ATTACHMENT D1

**Uranium One ISR Wellfield Hydrologic Impact Analysis
(Response to RAI 56)**

RAI 56

POTENTIAL IMPACTS FROM IRRIGATION WELL SMITH #1

ATTACHMENT D2

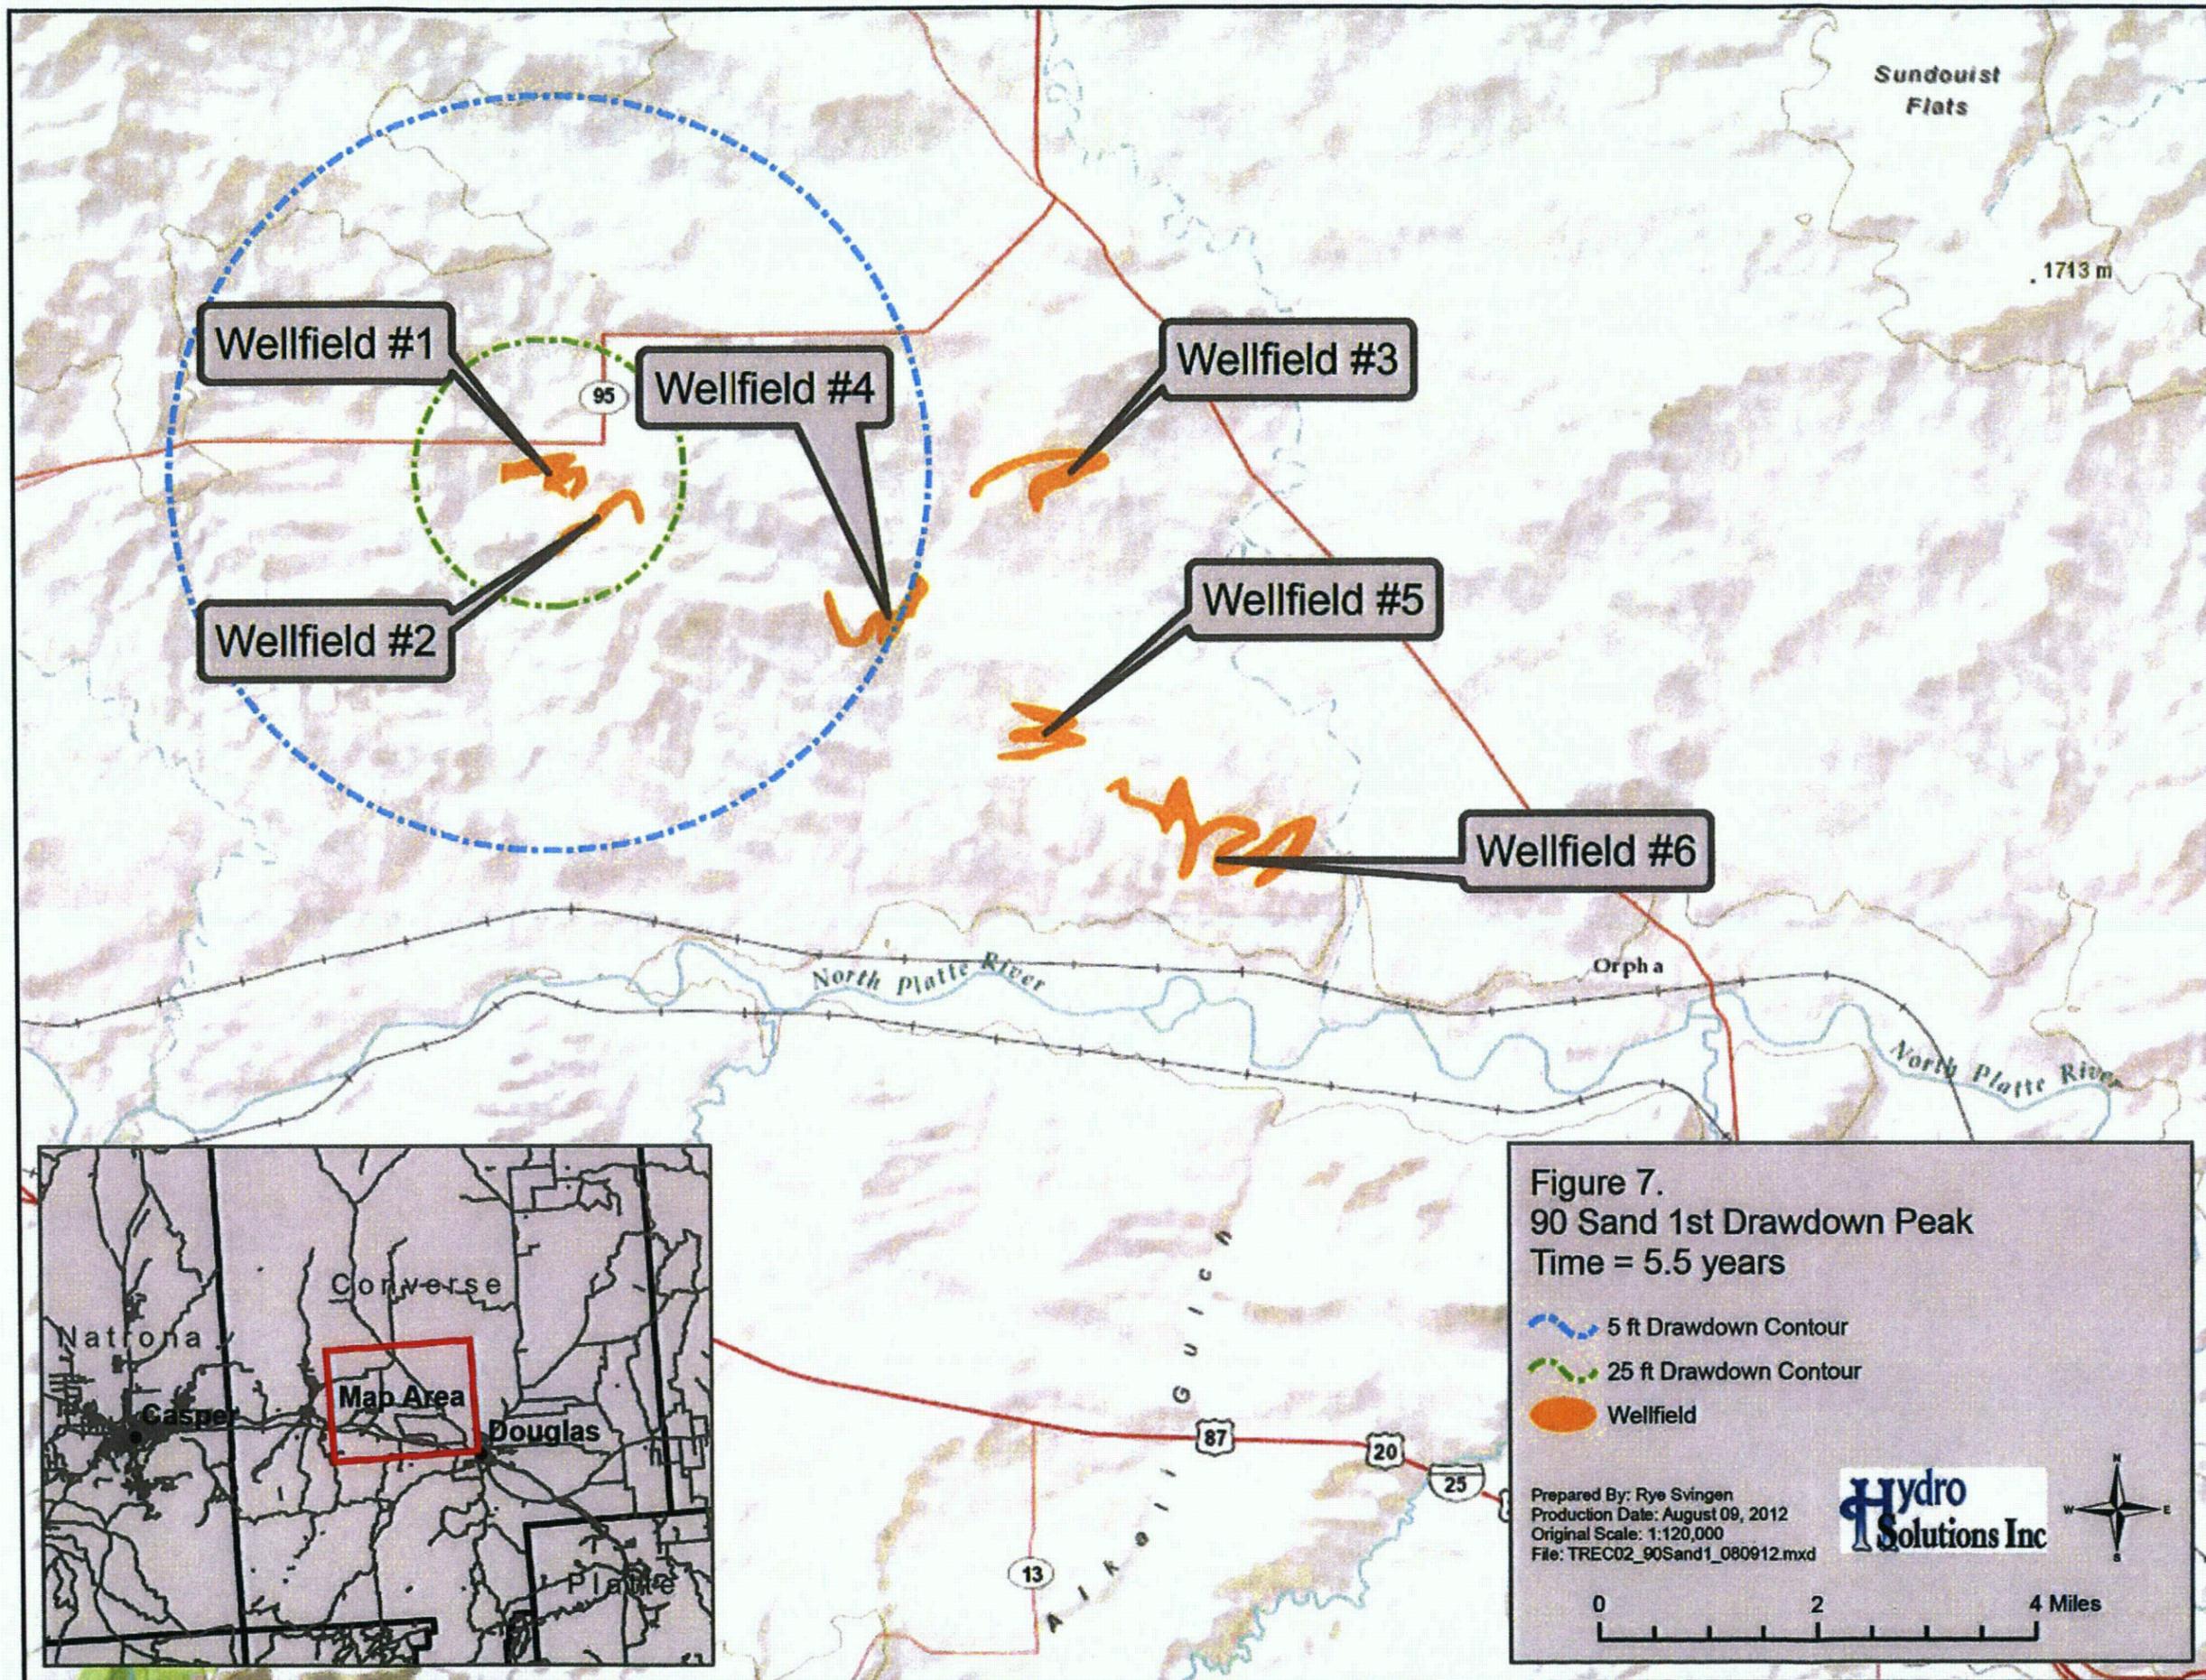
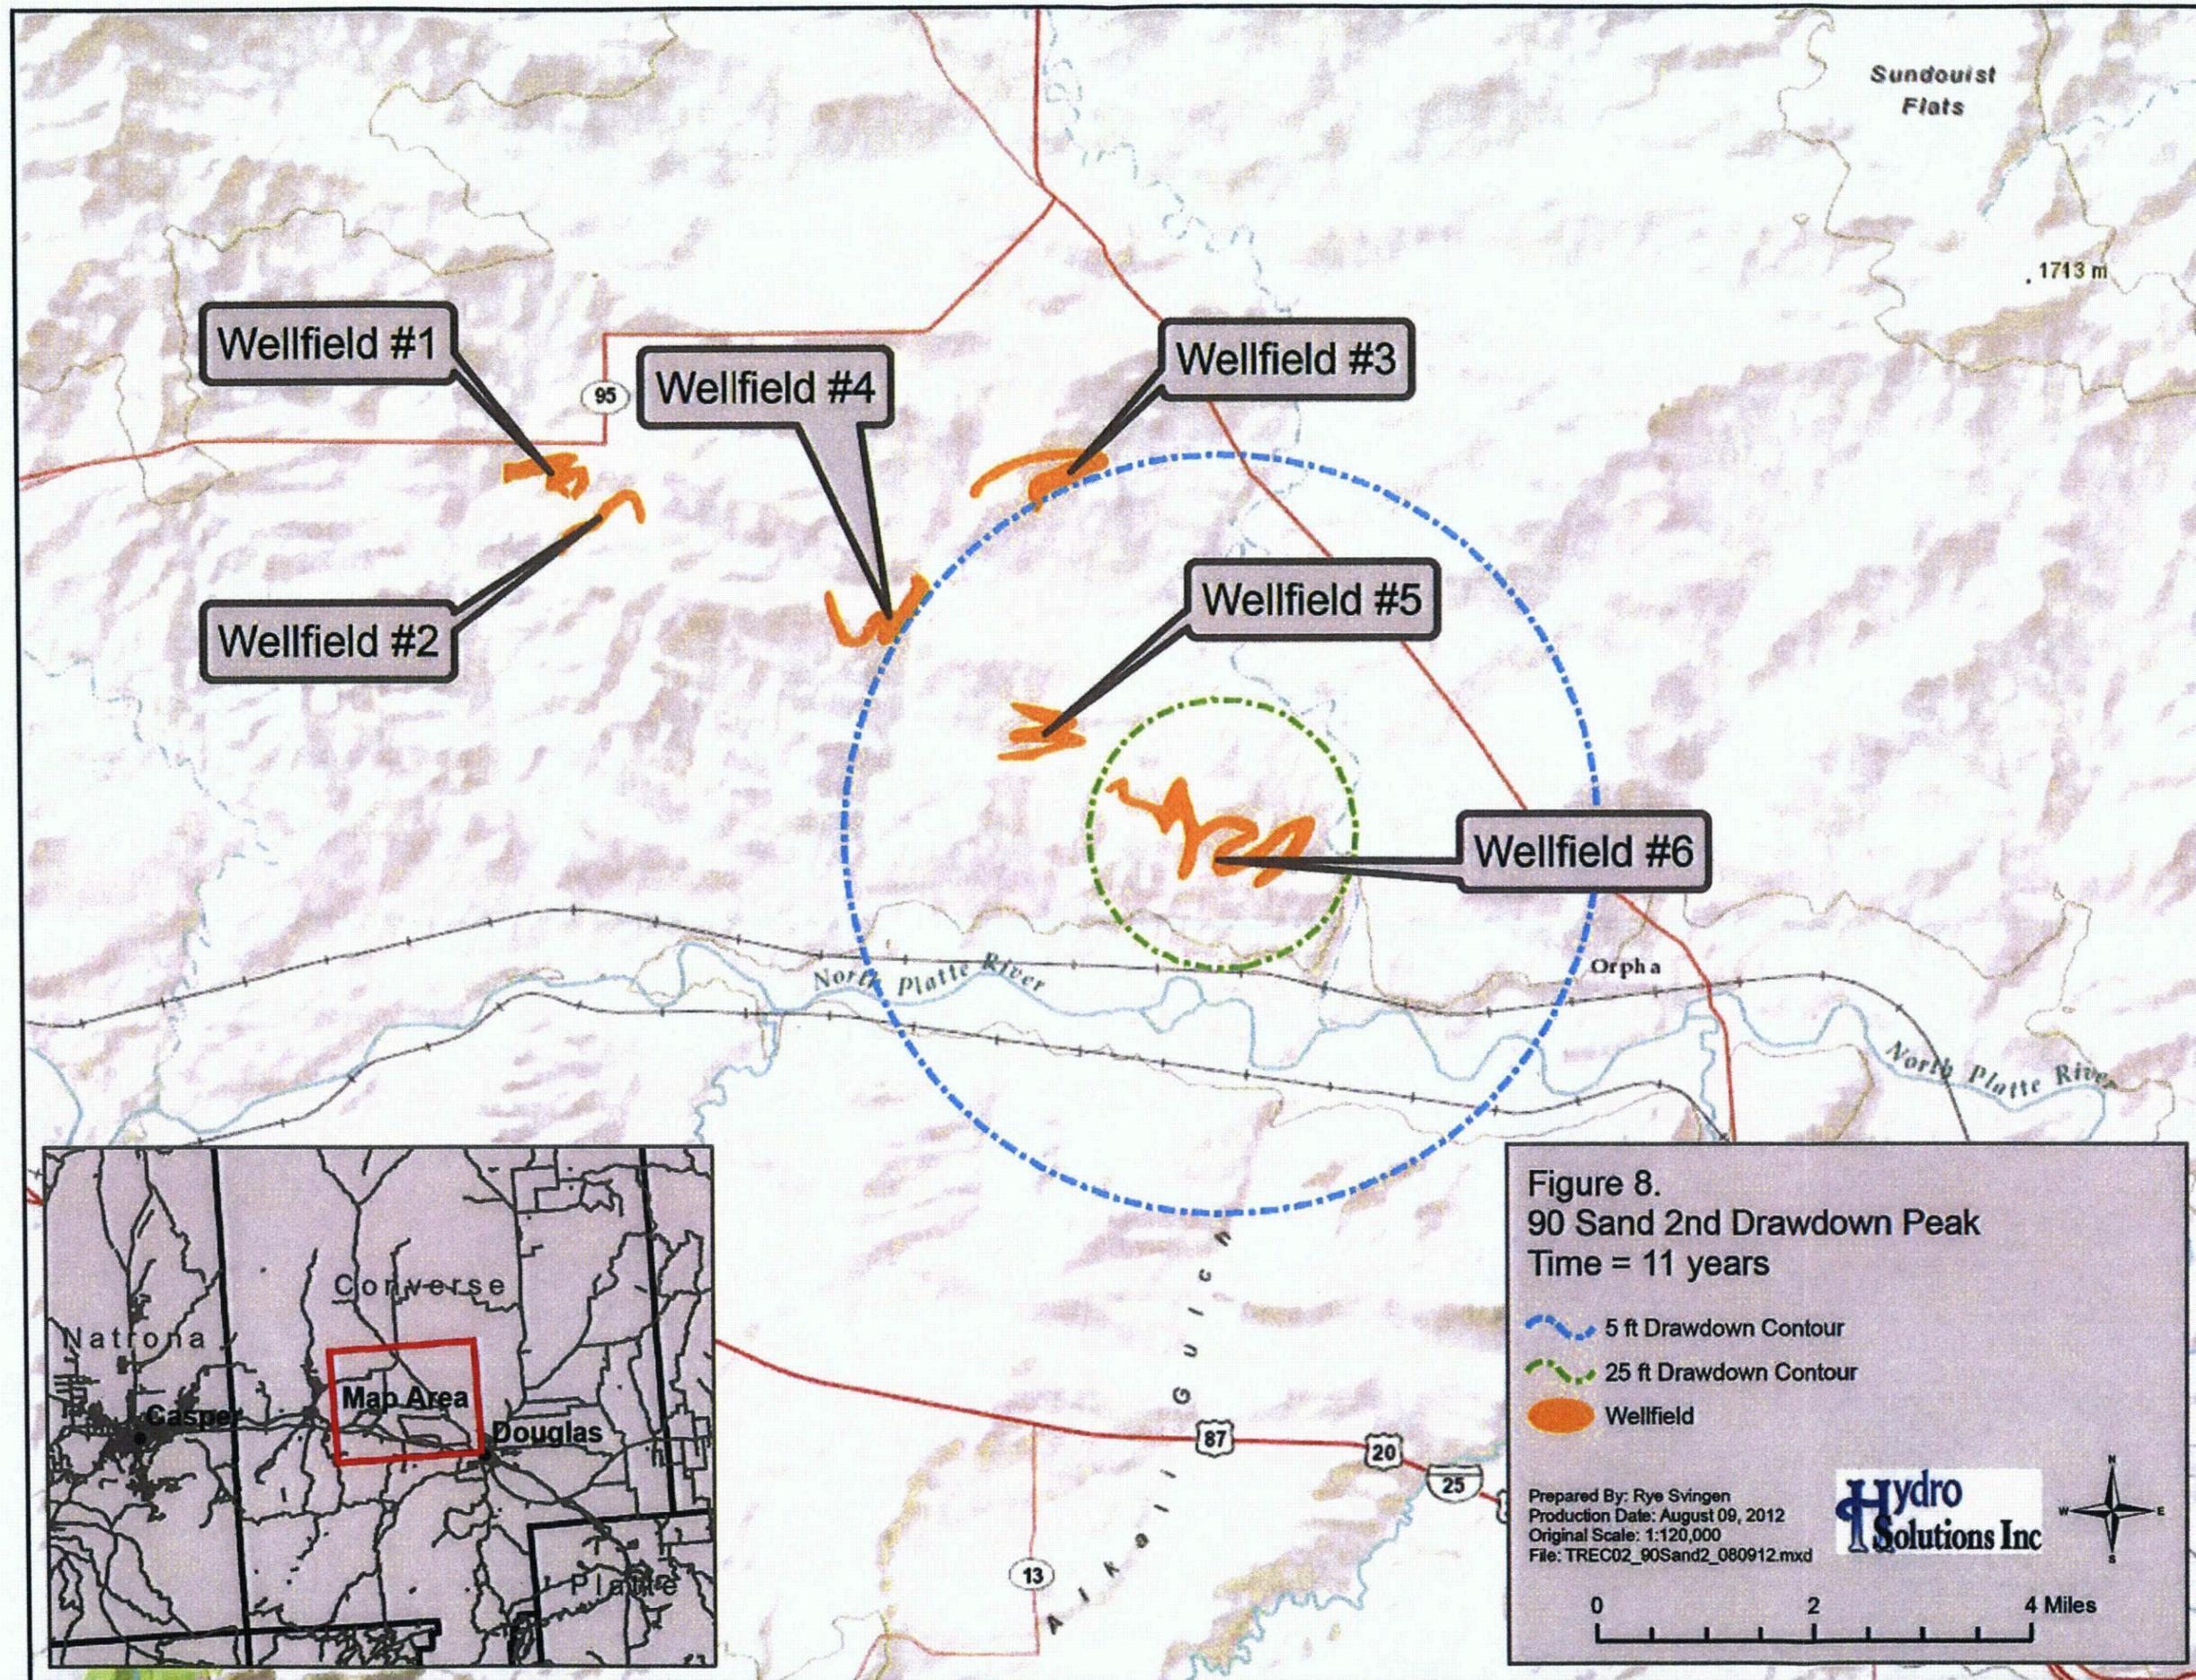
TR Section 3.1.6.1 provides the ROI for the 90 sand, 80 sand, and 70 sand as 550 ft, 500 ft, and 750 ft, respectively, based on the aquifer pumping tests. The TR also states there would be no impact to groundwater levels outside the project boundaries based on these estimates for the proposed bleed rate (15-45 gpm). These ROI were derived based on observations during the aquifer testing of these sands but the TR provided no calculations to support these numbers. Staff does not agree with Uranium One's definition of ROI. In practice, the ROI is defined by a function of transmissivity (T), time (t) and storage coefficient (S) in consistent units (Bear, 1979).

Staff requires the ROI and drawdown which will be realized at each satellite to assess the impacts of consumptive use on surrounding private wells and to provide reasonable assurance of the safe operation of the satellites.

Uranium One should provide: (a) the ROI using the estimated T, S and the time of production and restoration for each satellite wellfield; and (b) a prediction of the drawdown for each satellite wellfield within 2 km for each phase of operation using the appropriate consumptive use (e.g. 15-45 gpm).

A Theis-based analytical drawdown model for the 70, 80 and 90 Sand units at the proposed project was completed using site-specific aquifer parameters. The production sands of the Ludeman Project satisfy the assumptions required by the Theis model to the extent generally accepted for this type of hydrogeologic evaluation. Project-specific assumptions and limitations have been noted and discussed in this Memorandum. Model inputs were entered into AQTESOLV software, and graphs were produced showing the predicted time-drawdown behavior of the proposed project wellfields. Drawdown contour

Drawdown contours produced by the model were typically circular to somewhat elliptical in shape, depending on the distribution of active pumping centers in a given aquifer. At the time(s) of maximum drawdown, 25 foot drawdown contours for the 70, 80 and 90 Sand units had maximum radii that ranged between about 1.2 to 2.4 miles from their approximate pumping centers (wellfields) at the Ludeman site. Five foot drawdown contours for the 70, 80 and 90 sands typically had radii of approximately 3.4 to 4.8 miles from the pumping centers. A summary of approximate radial distances to the five and 25 foot drawdown contours for each aquifer is presented on Table 5.

Graphs showing the modeled time-drawdown characteristics of the pumping centers in each aquifer over the duration of the project are presented on Figures 1–3. Results of the analytical drawdown modeling are also presented as drawdown contour maps on Figures 4–8. Due to the operational schedules of the 80 and 90 Sand units, two distinct drawdown peaks were noted in the model output, which correspond to unique areal drawdown patterns. Thus, individual contour maps were prepared for both the first and second peaks in these cases.
